**Broad Development Parameters of the Indicative
Development Proposal in Respect of Application No. Y/YL-LFS/14**
关于申请编号 Y/YL-LFS/14 而只作指示用途的拟议发展计划的概括发展规范

Application for Amendment of Plan Under Section 12A of the Town Planning Ordinance (Cap.131) for Proposed Residential Development and Social Welfare Facility (Child Care Centre) at Various Lots in D.D. 128 and D.D. 129, and Adjoining Government Land, Lau Fau Shan, Yuen Long, New Territories (Planning Application No. Y/YL-LFS/14)

Application for Amendment of Plan Under Section 12A of the Town Planning Ordinance (Cap.131) for Proposed Residential Development and Social Welfare Facility (Child Care Centre) at Various Lots in D.D. 128 and D.D. 129, and Adjoining Government Land, Lau Fau Shan, Yuen Long, New Territories
 (Planning Application No. Y/YL-LFS/14)
Responses to Comments

Indicative Hammerhead for the Proposed Layby

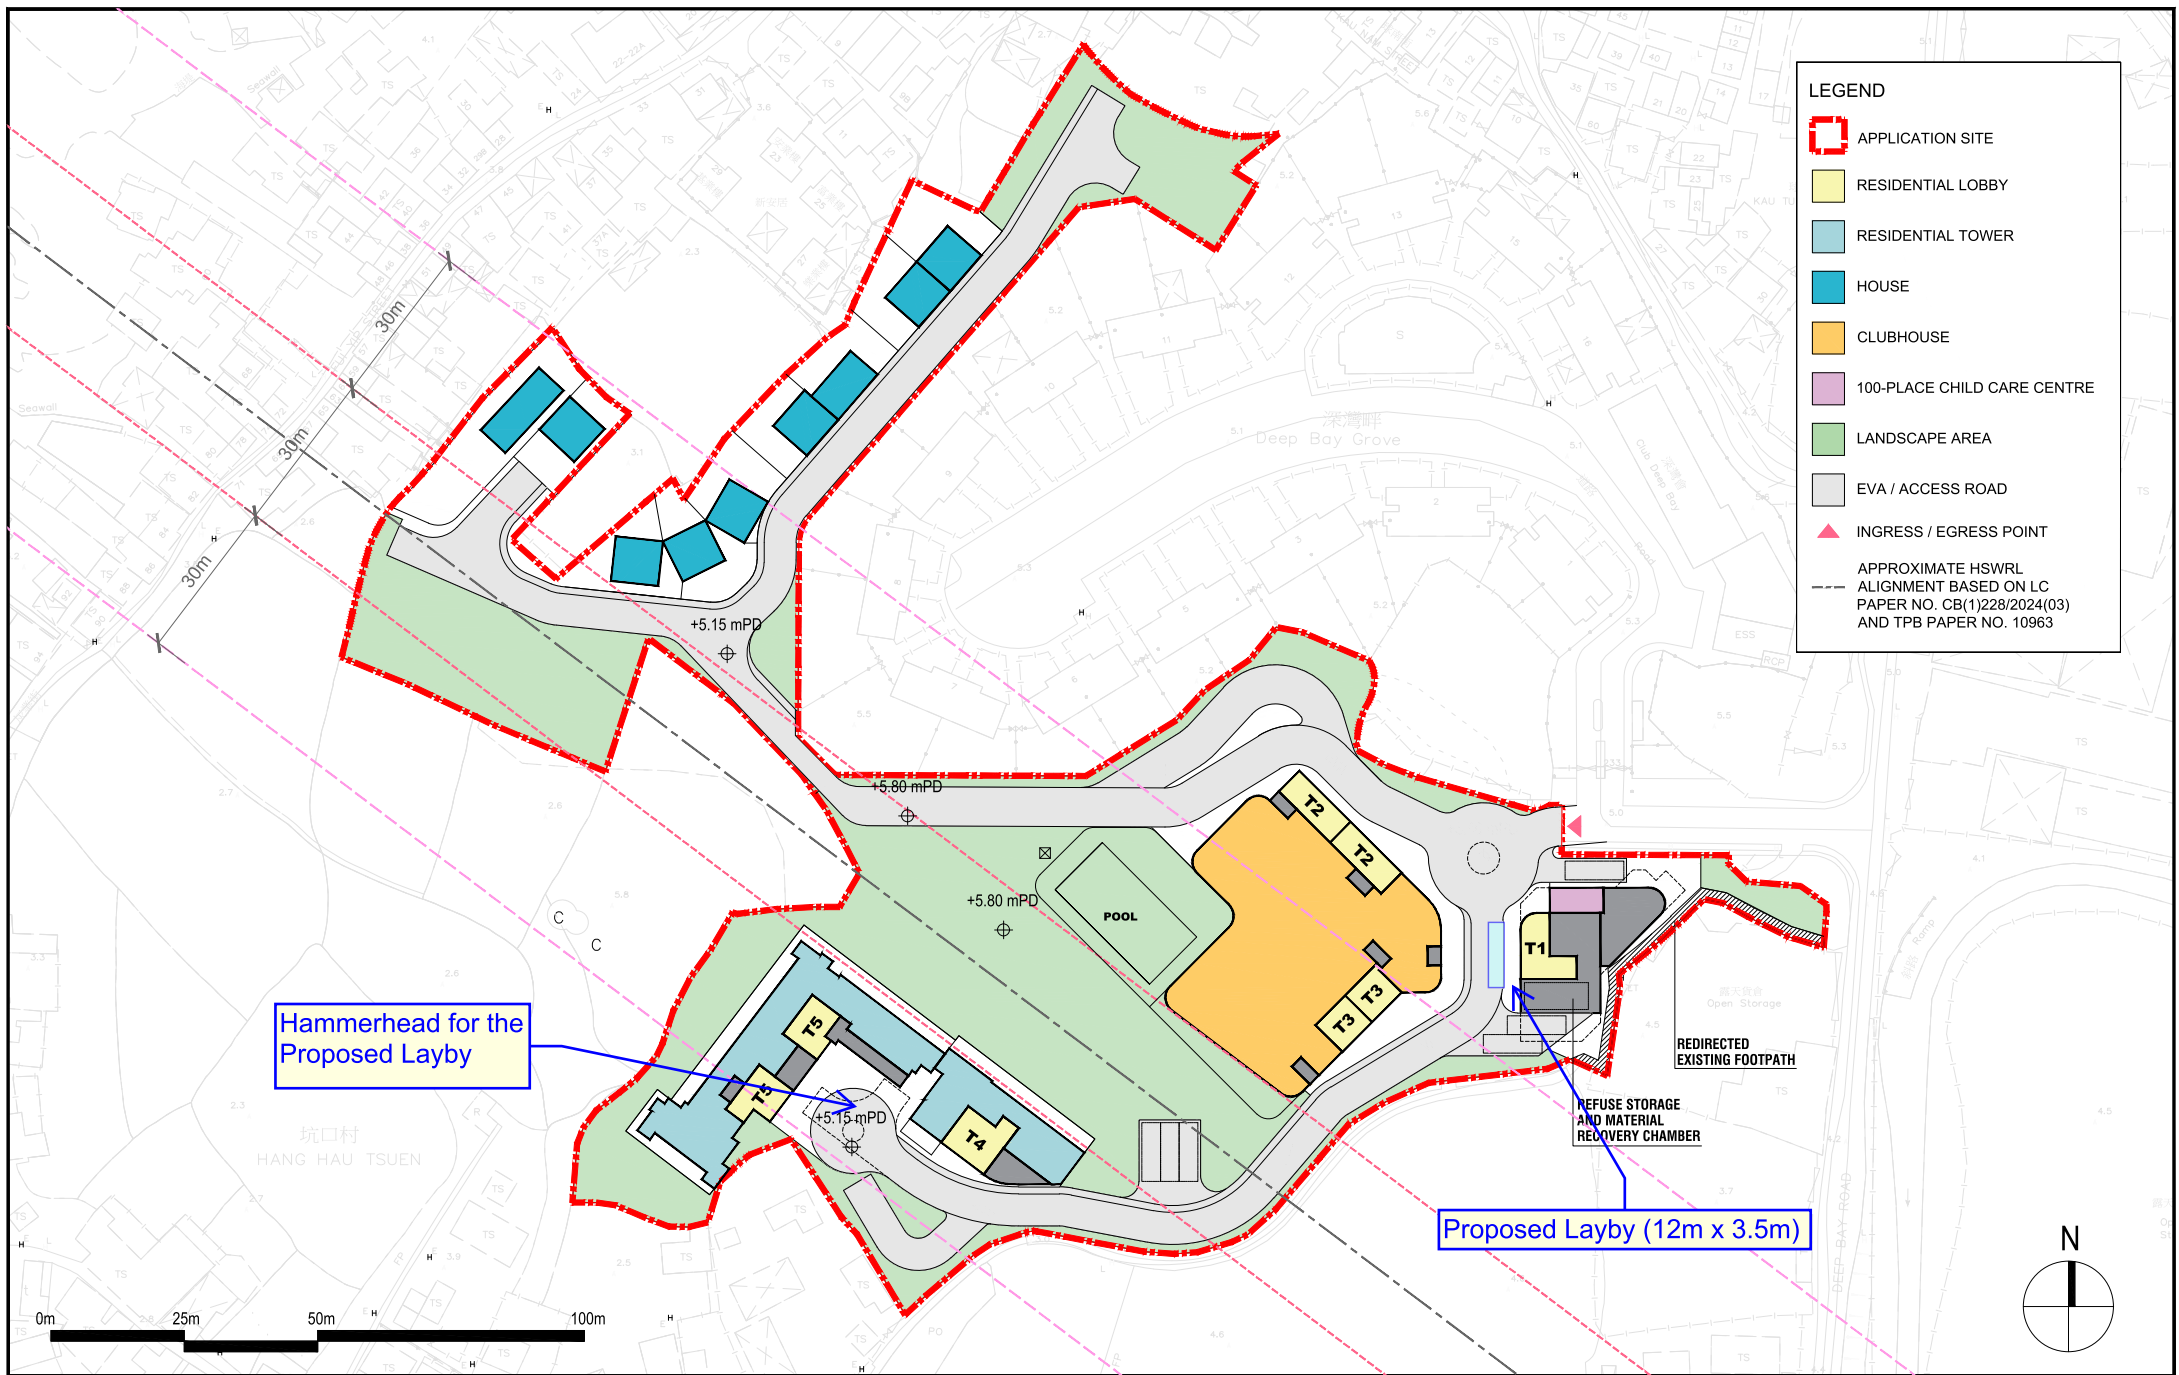
No.	Comments	Responses
	<p>please clarify whether the population and employment in the intensified HSK/HT NDA have been taken into account. Furthermore, please clarify if LATM are used in your assessment.</p> <ul style="list-style-type: none"> - In Section 3.2.2 of Annex E, please consult HyD on the latest progress of PWP Item No. 6878th(Part) regarding widening of Deep Bay Road. - Annex F: With reference to the mode hierarchy and the similar arrangement for LFS transitional housing, the nearby GMB services (serving Deep Bay Road) and MTR feeder bus services would be enhanced, subject to passenger demand. In this connection, the proposed layby (12m X 3.5m) within the development should be reserved for the prospective GMB services, with flexibility for operation of other types of services (e.g. shuttle bus) only if no relevant public transport services were available. In any case, the exact plan for the transport services is subject to TD's further assessment and review, with due consideration to the development and planning of the transport system/services in the LFS area near the time. - Annex F: Please indicate the turnaround facility for the proposed layby. 	<p>New Development Area”, the Hung Shui Kiu/Ha Tsuen New Development Area (HSK/HT NDA) will be developed in phases. Phase 1 and Phase 2 developments are scheduled to be completed by 2032 whilst the Phase 3 development is scheduled to be completed in 2037/2038.</p> <p>Phase 1 and Phase 2 developments of HSK/HT NDA would be completed before the design year 2036 and has been considered in the traffic forecast. Nevertheless, taking into consideration that the Phases 1 & 2 developments are not in close proximity to the identified study area, their traffic impact would be limited on the identified study area. Therefore, the 2036 reference traffic flows were derived by adopting appropriate growth rates onto the observed traffic flows, instead of using the LATM.</p> <p>Advice from HyD on the latest progress of PWP Item No. 6878th(Part) - widening of Deep Bay Road has been sought. Please find attached the reply email from HyD in Annex E for your information.</p> <p>Noted. The proposed layby (12m X 3.5m) within the development will be reserved for the prospective GMB services, with flexibility for operation of other types of services (e.g. shuttle bus) only if no relevant public transport services were available.</p> <p>The hammerhead for the proposed layby is illustrated in Annex F. Details of the</p>
